SERVICE BULLETIN

Date: November 5, 2014
Update Number: S2014-02
Subject: 24VDC Commercial Gate Operator Board Compatibility
Products Affected: CSL24VDC and CSW24VDC

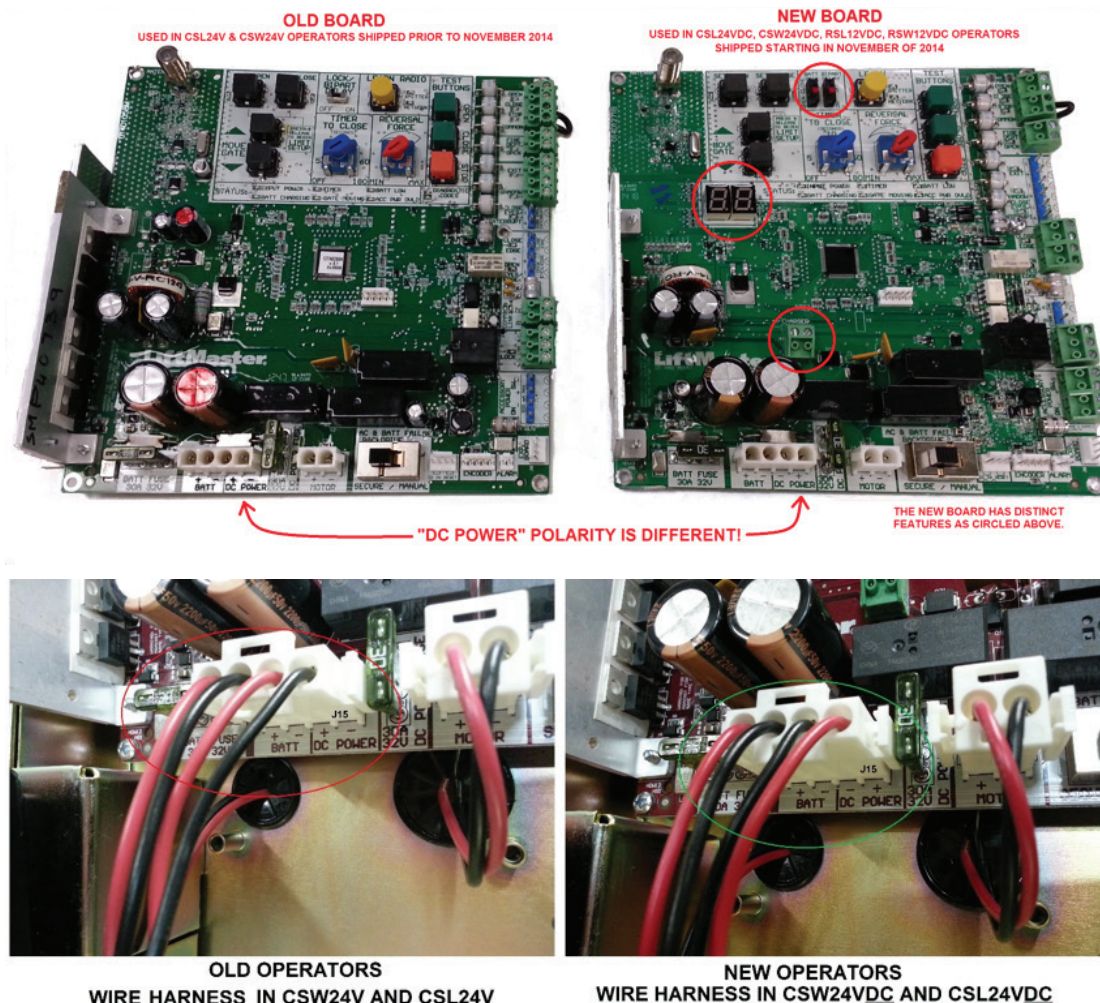
**NOTE THE POLARITY DIFFERENCE OF THE "DC POWER" CONNECTION
AND THE WIRE COLORS GOING TO THE J15 CONNECTOR**

- b. You will need to reverse the polarity on the J15 plug in order to use the new boards in older operators. Failure to change the polarity of the harness will result in the blowing the fuse on the control board.

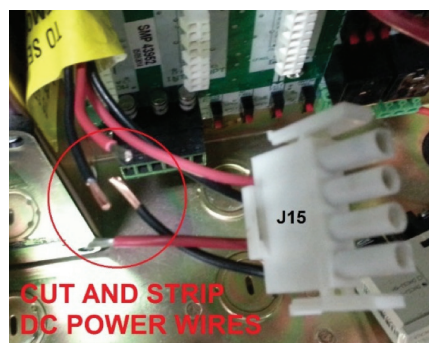
1. Turn off AC power to the operator.
2. Remove the cover on the operator.
3. Remove the clear e-box cover.
4. Switch off the AC power switch in the operator.
5. Disconnect the J15 power connector on the main board.
6. Disconnect all other wires connecting to the control boards.
7. Remove the old main board and expansion board by removing the Philips screws that hold them in to the e-box.
8. Swap the polarity of the red and black "DC POWER" wires that go to the J15 plug.
 - a. Identify the DC power wires that go to the J15 plug. These wires connect to the bridge rectifier located on the back side of the E-box. The J15 connector is keyed with D-shaped plugs in the end positions. Note the orientation of the D-shaped plugs in the picture below where the "DC POWER" wires connect to.

- b. Cut the "DC POWER" red and black wires 1.5 inches from the white J15 connector.
 - i. DO NOT CUT THE RED AND BLACK BATTERY WIRES!
- c. Strip 0.25 inches of insulation off of the 4 resulting wires

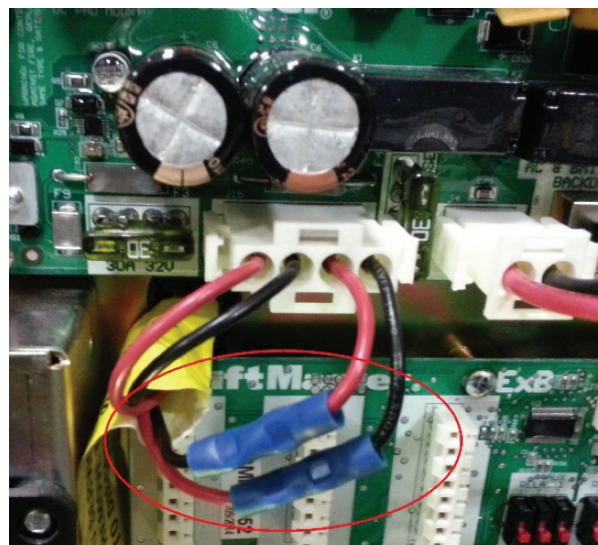
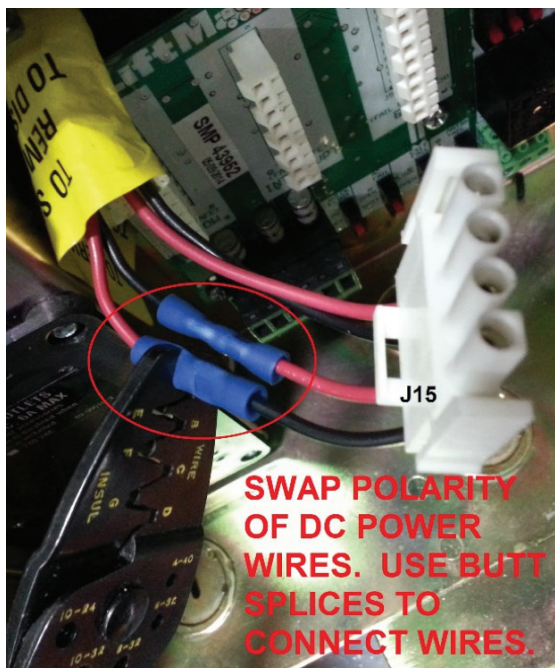
- d. Using butt splices, splice the DC POWER wires back together with the polarity inverted. The finished product should look like this:
